# Request for Proposal

Date: 8/9/2023  
Project Name: UA 310 ARKV Renovation  
Project No.: 21085  
Owner: University of Arkansas - Fayetteville

**RFP NO: 02**

PROPOSAL REQUEST NUMBER: TWO (2)

**E1.03**

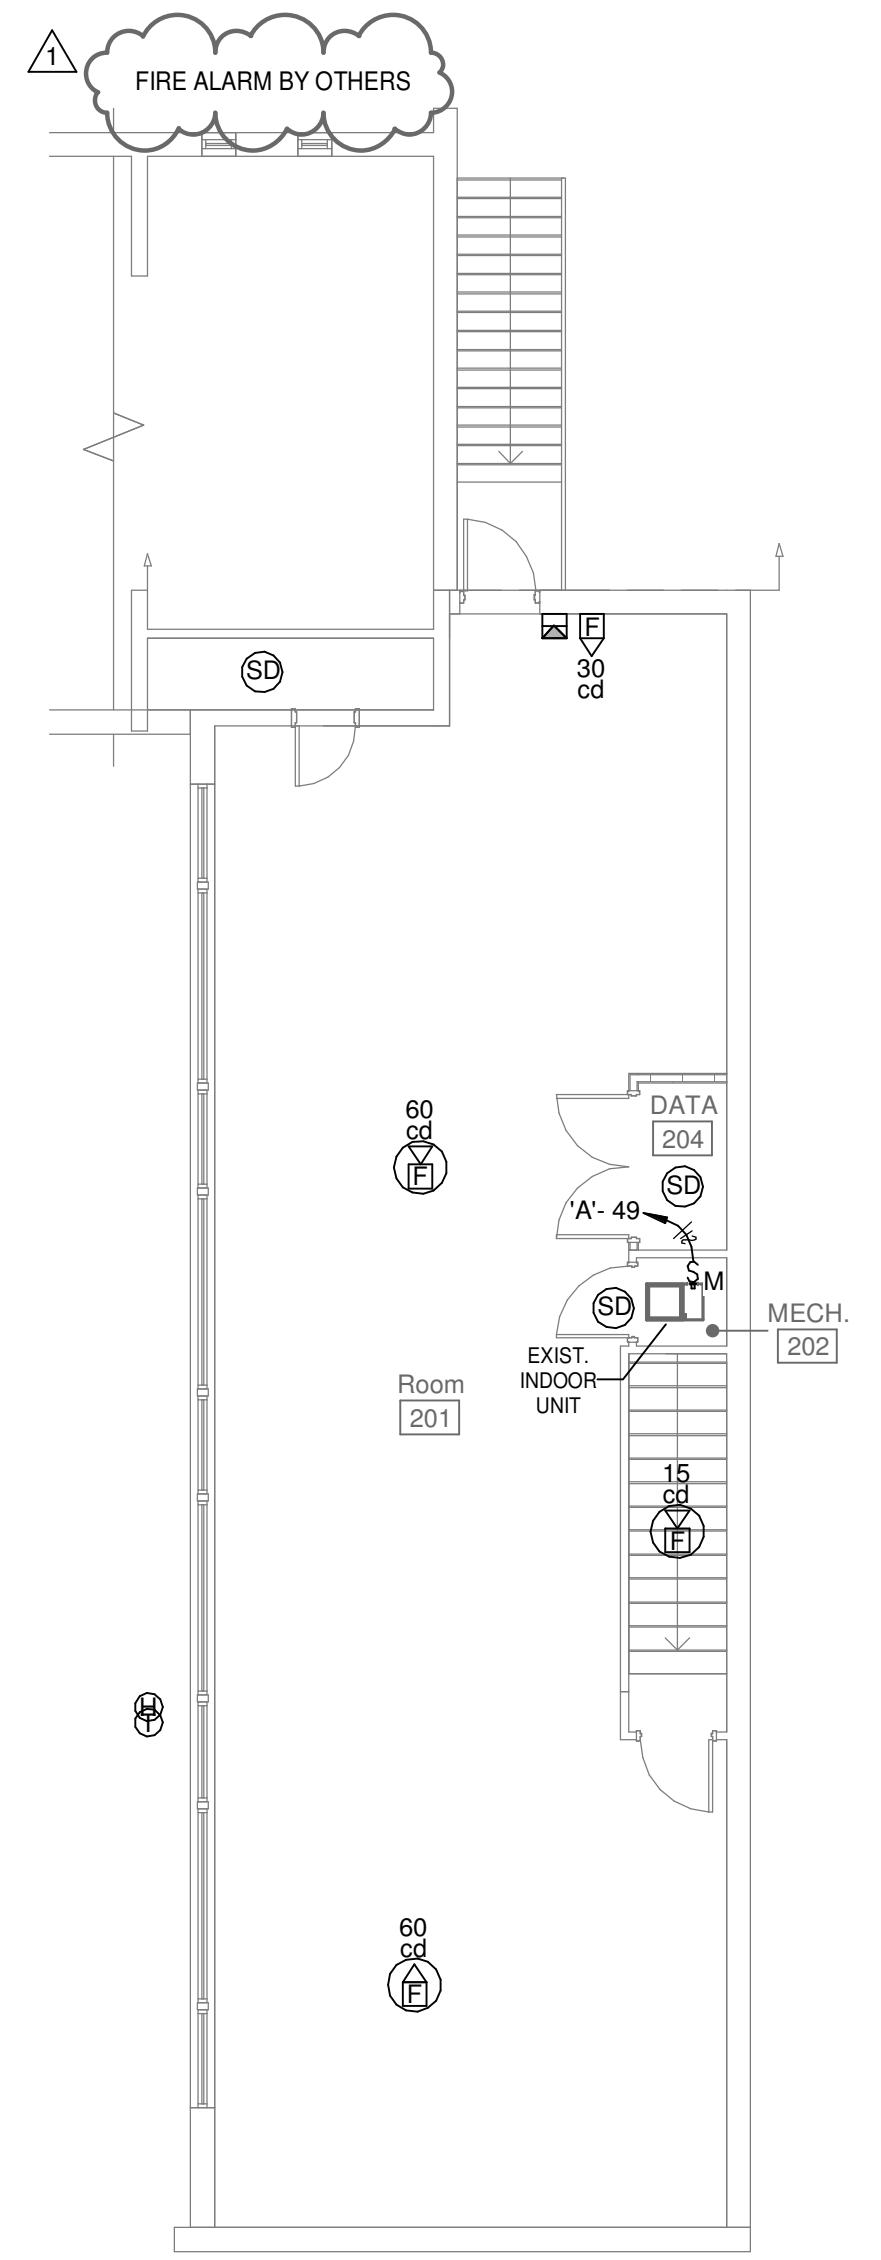
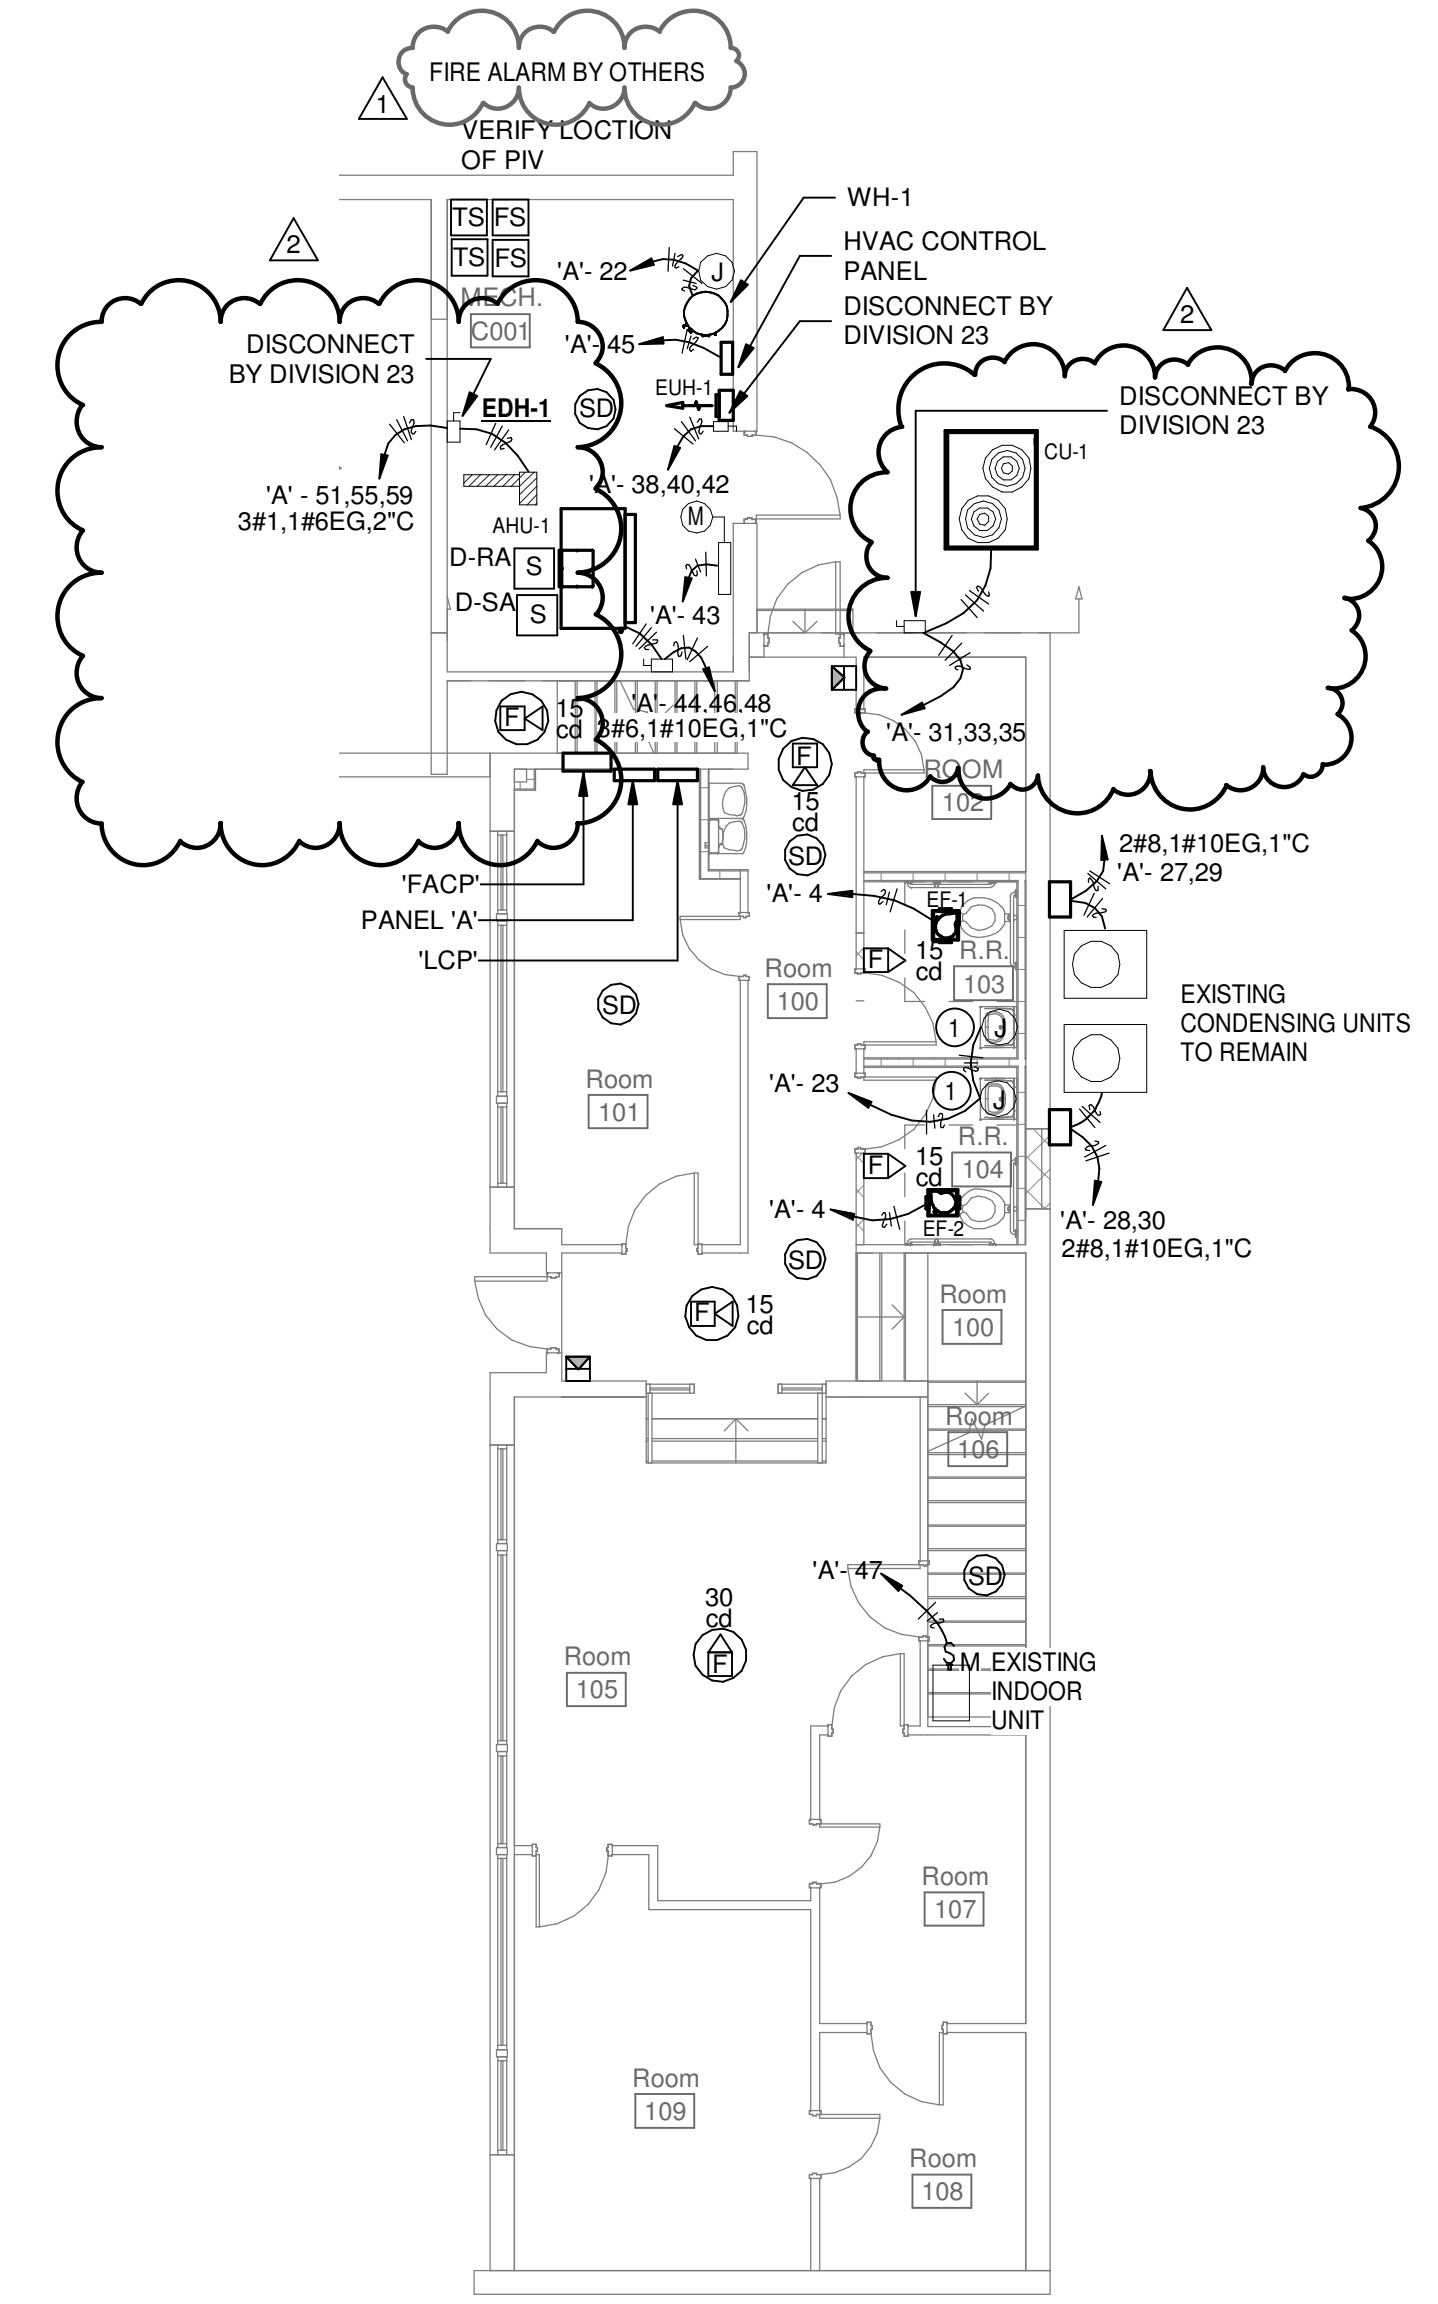
- A1.** REFER TO SHEET M1.01 AND M2.01 FOR DUCTWORK ROUTING REVISIONS. ADDITIONALLY, EDH-1 HAS BE REVISED AND RELOCATED, EDH-2 HAS BEEN DELETED, AND CU-1 HAS BEEN RELOCATED.
- A2.** REFER TO SHEET M4.01 REVISIONS TO THE DUCT HEATER SCHEDULE.
- A3.** REFER TO SHEET M5.01 REVISIONS TO THE DUCT HEATER CONTROLS DIAGRAM AND SEQUENCE OF OPERATIONS.
- A4.** REFER TO SHEET E1.03 FOR REVISIONS TO THE DUCT HEATER EDH-1 AND THE DELETION OF EDH-2. CU-1 WAS ALSO RELOCATED.
- A5.** REFER TO SHEET E2.01 FOR REVISIONS TO PANEL "A". A NEW 125A/3P BREAKER SHALL BE PROVIDED FOR EDH-1. THE ORIGINAL BREAKERS FOR EDH-1 AND EDH-2 SHALL BE LABELED AS SPARE.
